Parramatta Aquatic Centre

Independent Transport Assessment

City of Parramatta Council

24 November 2020

Figure 3 Proposed Park Parade bus lane reconfiguration

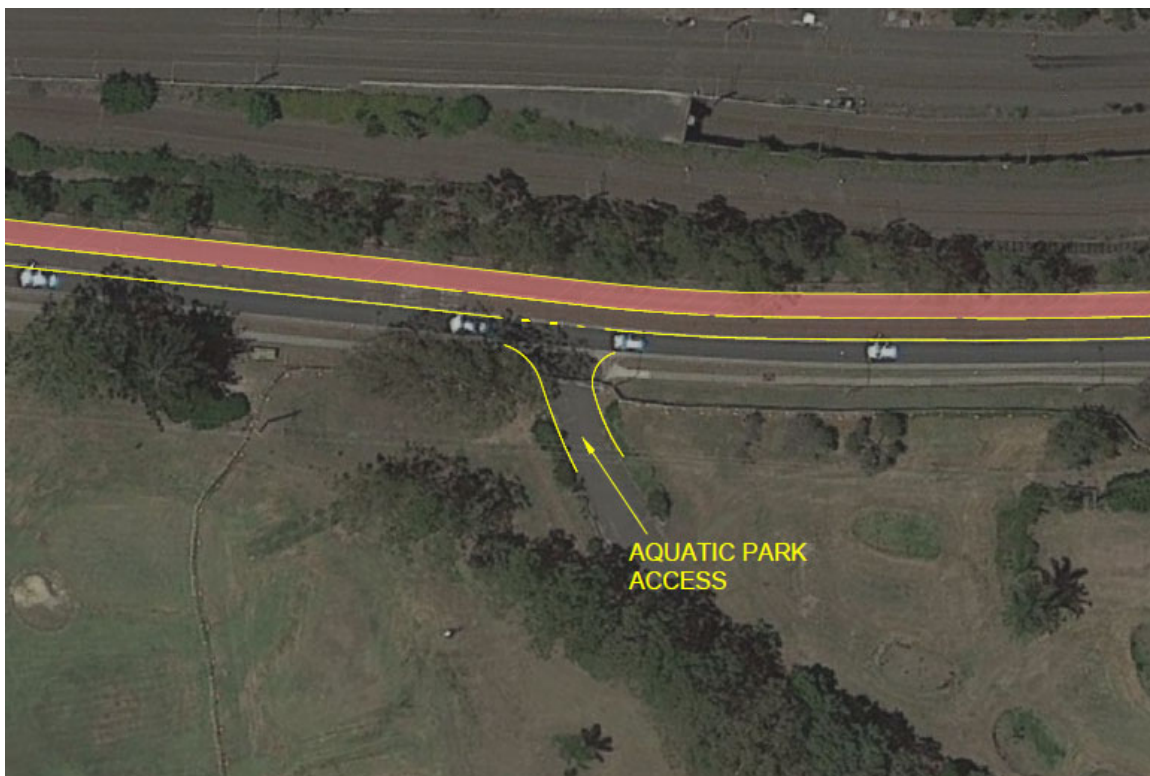
In September 2020 Council and JMT Consulting met with TfNSW to discuss options to permit vehicle access into and out of the site from all directions. An option was presented which relocates the existing Park Parade bus lane from the centre lane to the kerbside lane, which would then allow for right turns into and out of the site. This configuration is illustrated in Figure 3 below.

TfNSW have since provided in-principle support to the above arrangement subject to the following information being provided by the applicant:

- SIDRA traffic modelling to confirm that the shared through & right turn lane on Park Parade can accommodate forecast traffic demands (noting my preliminary traffic modelling indicates this should be acceptable)
- Appropriate sight distances are provided for traffic turning right into and out of the site
- Appropriate signage is provided for vehicles turning right into the site so they are aware of the access arrangements (reducing the likelihood of rear-end crashes)

Item	Recommendation
Vehicle site access	<p>Vehicle access and egress should be provided from all directions by relocating the existing Park Parade bus lane from the centre lane to the kerbside lane, which would then allow for right turns into and out of the site.</p> <p>The final design of the reconfigured bus lane and vehicle site access should be endorsed by City of Parramatta Council and Transport for NSW prior to the works being undertaken.</p>
Signage and wayfinding	<p>Appropriate signage should be provided along Park Parade prior to the access driveway in accordance with Austroads Guidelines, in order to provide advanced warning to drivers of vehicles turning into the site and to reduce the possibility of rear end collisions.</p> <p>A signage plan should be submitted to City of Parramatta Council for endorsement prior to a construction certificate being issued.</p>
Car parking	<p>The development shall provide for a minimum of 197 car parking spaces, comprising of:</p> <ul style="list-style-type: none"> • 6 accessible parking spaces (designed in accordance with AS2890.6) • 5 spaces reserved for pick up and drop off • 186 standard car parking spaces designed in accordance with AS2890.1, user Class 2

Figure 5 Recommended drop off / pick up bays

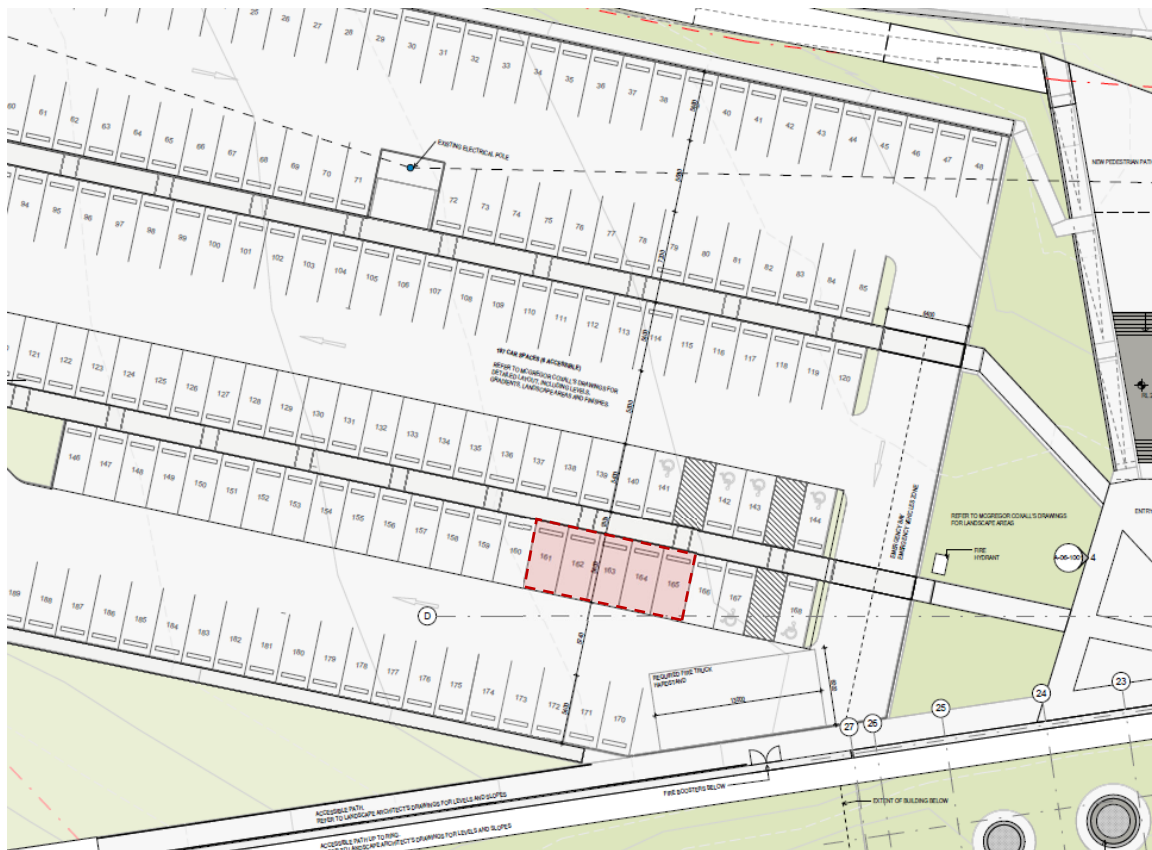
The proposal initially included the provision of a shared area adjacent to Park Parade for the use of both buses/coaches as well as kiss and ride (drop off / pick up). This arrangement would have presented a risk in that vehicles waiting to pick up visitors from the site in this area would prevent buses and coaches from adequately manoeuvring into space to pick up passengers. Conversely when two coaches are parked in this area there will not be any space for general vehicles to drop off or pick up passengers. This would then create a risk of people being dropped off or picked up within the main circulation roadway or queueing back onto Park Parade and impacting the movement of general traffic and public transport.

From a functionality and management perspective it is desirable to have clear separation between these different user groups. This would lend itself towards providing for kiss and ride within the main car park and providing dedicated access for buses and coaches within the drop off area.

The updated car park design provides for this separation of uses by allowing for five drop off / pick up spaces in the south-eastern corner of the car park. These spaces (noted as spaces 161 – 165 in Figure 5) should be signposted as '5 minute parking' to encourage a high turnover of spaces. Vehicles entering and leaving the car park within a certain period of time (for example 15 minutes) should not be subject to any parking fees so as to not discourage people from using these drop off / pick up spaces.

Item	Recommendation
Bicycle parking	49 bicycle parking spaces are to be provided including 13 secure spaces for staff members and 36 bicycle racks for visitors and/or staff members
Event traffic and transport management	Prior to an occupation certificate being issued, an Event Traffic and Transport Management Plan should be prepared that ensures the event traffic and transport for events held are safely and efficiently operated for the various event types, including any altered traffic arrangements. The plan shall be prepared in consultation with the Sydney Coordination Office TfNSW and City of Parramatta Council.
Drop off / pick up	A minimum of five parking spaces should be provided within the main car parking area to facilitate drop off and pick up activity. Parking spaces 161-165 inclusive as noted on the car park plans should be signposted as '5 minute parking'. Vehicles entering and leaving the car park within a certain period of time (for example 15 minutes) should not be subject to any parking fees so as to not discourage people from using these drop off / pick up spaces.
